MILITARY SPECIFICATION

TEST STAND, AIRCRAFT HYDRAULIC SYSTEM, TRAILER-MOUNTED, A/M27T-2, ELECTRIC-MOTOR-DRIVEN, TRIPLE SYSTEM

This amendment forms a part of Military Specification MIL-T-26398D(USAF) dated 7 February 1967.

FIGURE 1 Schematic of Hydraulic System

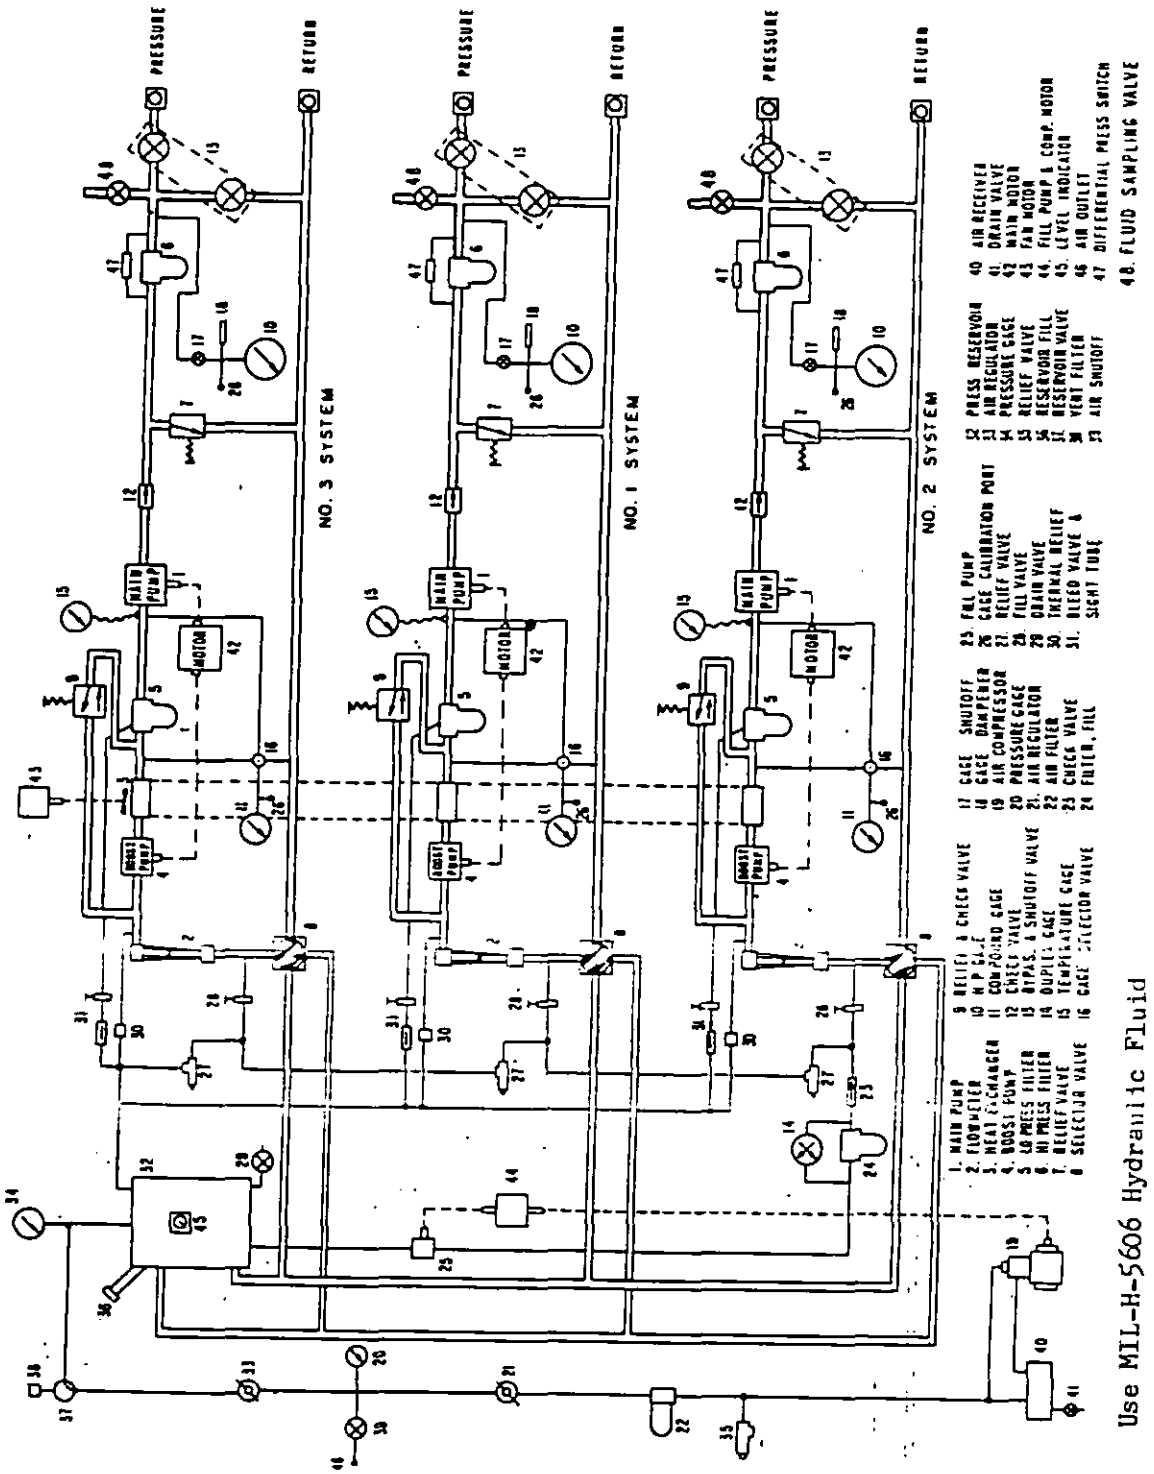
Page 5, figure 1: Delete figure 1 and substitute the attached figure 1. Figure 1 forms page 2 of this amendment.
